Date: March 11, 2003

To: T10 Committee (SCSI)

From: George Penokie (IBM/Tivoli)

Subject: SAS: SP_DWS Wording Changes

Figure 1 — SP_DWS (phy layer dword synchronization) state machine

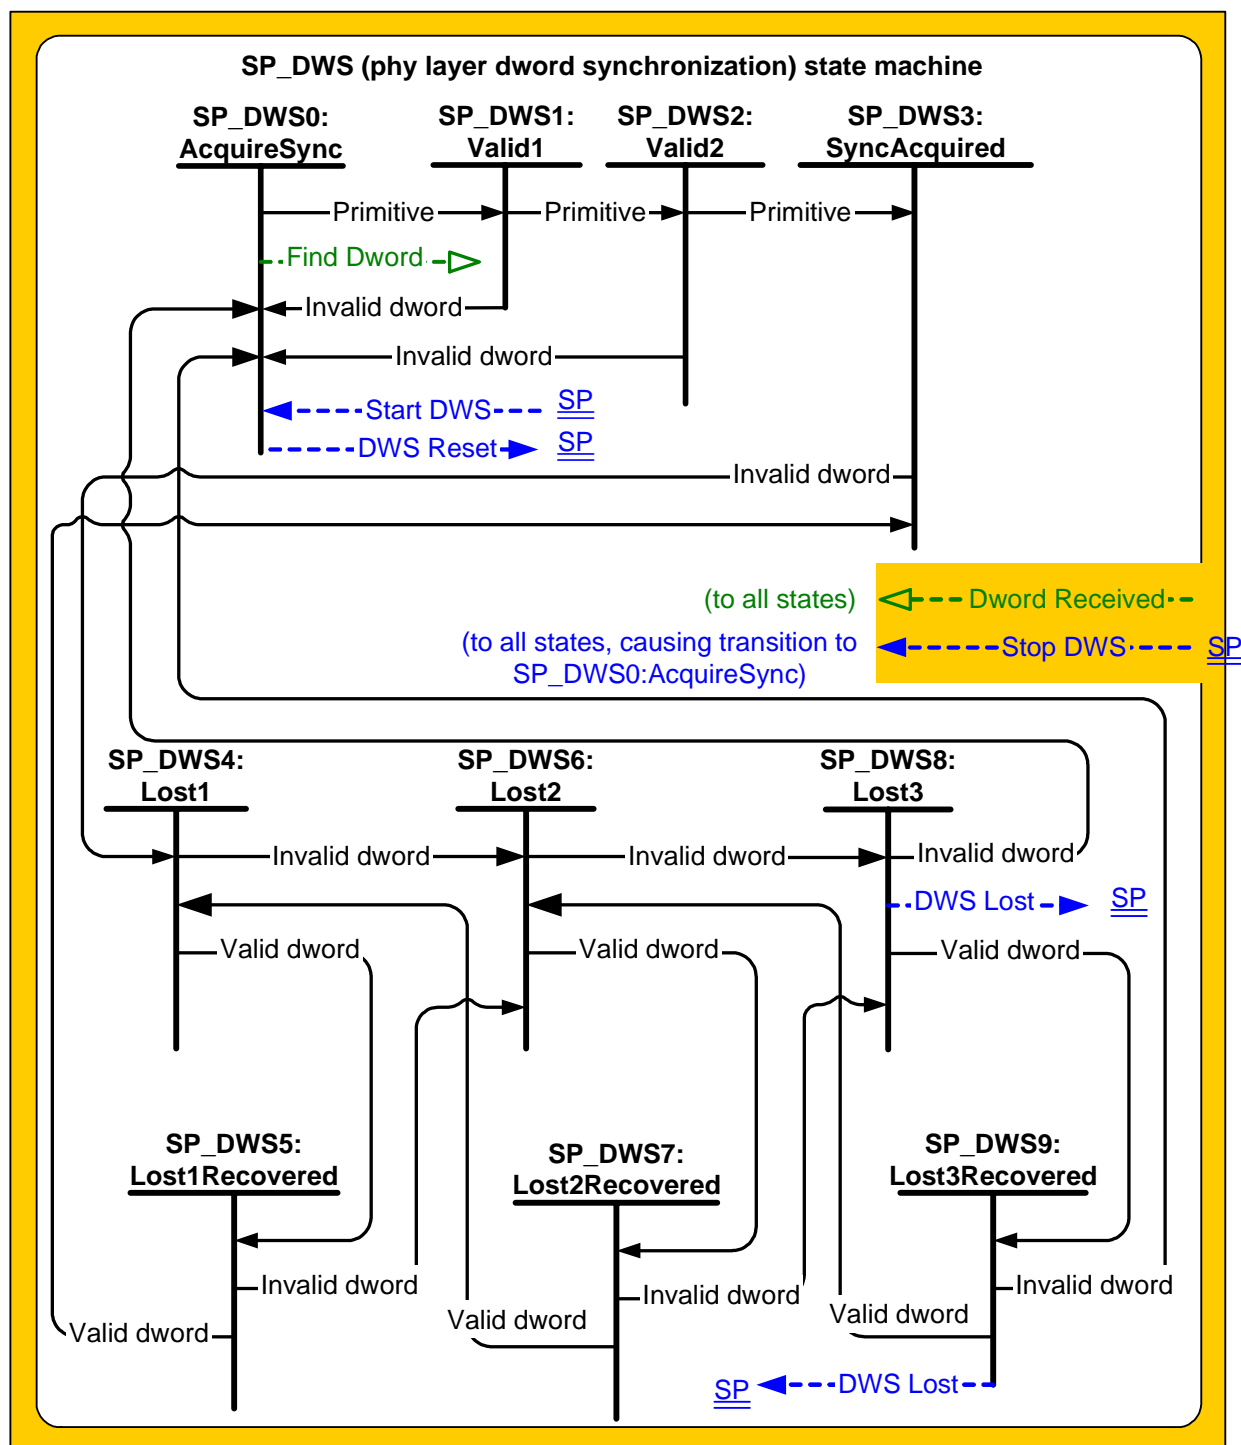
Figure 1 shows the SP_DWS state machine.
